SAFETY NOTICE

110002

Date: June 27, 2011

Subject: Floor Loading Information

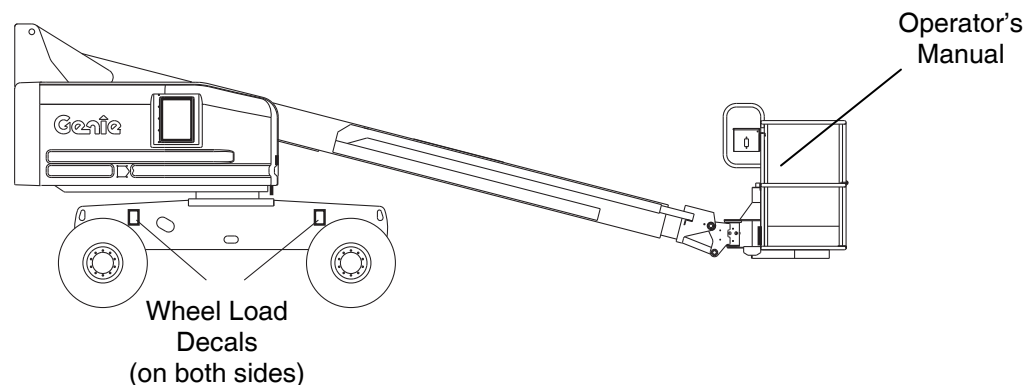
3. Locate and destroy the following wheel load decals on the machine and in your inventory.

P/N 82588

P/N 82629

Note: You may continue using the machines affected by this safety notice under the following conditions:

**Models S-40 : on surfaces that can support a wheel load up to
6700 lbs / 3040 kg.**

**Models S-45 : on surfaces that can support a wheel load up to
8500 lbs / 3855 kg.**

6. Upon receipt of the kit, replace the decal and the Operator's Manual on your machine.
